Project:	Whitmore High School, Barry	Job No:	60571313
Subject:	Response to Local Highway Authority Comments on Planning Application		
Prepared by:	Matt Davies (Senior Consultant)	Date:	16/07/2019
Checked by:	Spiro Panagi (Associate Director)	Date:	16/07/2019
Approved by:	Spiro Panagi (Associate Director)	Date:	16/07/2019

This Technical Note provides a response to the highway observations of the Vale of Glamorgan, its role as Local Highway Authority (LHA), on a planning application for Whitmore High School (Reference: 2019/00435/RG3). The observations of the LHA and the response are set out in the table below.

<table><tr><th colspan="2">Phoenix 2 Duo (P2-15W with Elite 6x4 chassis)</th></tr></table>

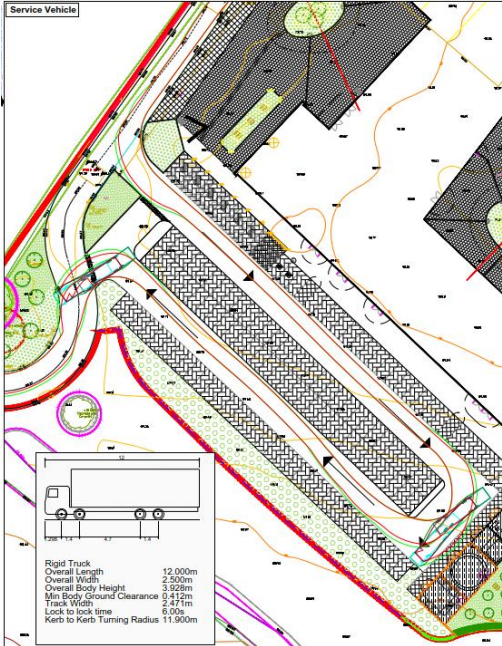
<p>specific vehicles are required for transporting these pupils.</p> <p>Any additional vehicles are capable of being accommodated within the existing parking provision on the site, and therefore no additional, or specific, parking is considered necessary.</p>																
8	<p>The zebra crossing points across the access road and the entrance to the car park could potentially cause conflict between pedestrians crossing as well as vehicles utilising the access / car park road. I consider that these crossing points require redesign to ensure that the safety of pedestrians / cyclists are not compromised.</p>	<p>There have since been discussions with the LPA on this matter. The pedestrian access near the signal-controlled junction has been removed, together with the link and associated zebra crossings, as shown on the extract from the revised masterplan below. Pedestrians from the direction of Stirling Road will instead utilise the proposed pedestrian access at the location of the existing refuge crossing, located between Stirling Road and the Fire Station. Pedestrians will use this crossing facility, as per the existing situation.</p> 																
9	<p>The transport Assessments show swept paths for a 9.86m refuse vehicle exiting the car park area. The Council utilise 11.2m vehicles and track runs need to be produced to ensure that the design can accommodate this type of vehicle. It is also considered that cars will circulate within this car park and a track run is necessary at the top end of the car park.</p>	<p>Swept path analysis has been undertaken for the requested size of refuse vehicle, as shown on the extract below and the attached drawing. This demonstrates that the larger vehicle can enter the car park, circulate and exit.</p>
